4278A-08

S	Е	R	V	I	С	Е	Ν	0	Т	Е
							SUPERSEDE	ES: None	)	
4278	8A 1kF	Iz/1M	Hz Ca	pacita	ance M	eter				
Seria	l Numbo	ers: 000(	000000	/ 2936J	02833					
Mod	lificatio	on prev	ents c	loggin	ig mem	ory car	d socket			
Dupl	icate Sei	rvice No	tes: Nor	ne						
To B	e Perfor	med By:	Agilen	t-Qualif	ied Perso	onnel				
Parts	Requir	ed:								
Part	No.	Qty.	D	escripti	ion					
0427	8-66510	1	Ν	lemory	Card Soc	eket Assy				
0427	8-00637	1	Р	Plate						
0427	8-01205	1	А	Angle						
0515	-1550	2	S	crew						
0535	-0004	2	Ν	ut						
					Not					
							hat do not yet ha	ave		
	-	the dust-	prevent	ve cove	er installe	ed.				
								C	Continued	
							DATE: 04 Jun	o 1002

## ADMINISTRATIVE INFORMATION

Figure 1. Dust-Preventive Cover Assembly

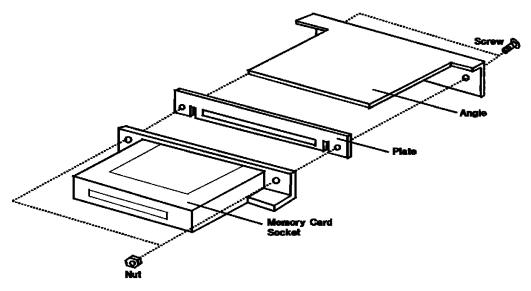
The memory card socket of 4278A which used in a production line may clog up with dust.

Replace the defective memory card socket assembly by installing the new one with the dust-preventive cover, refer to Figure 1.
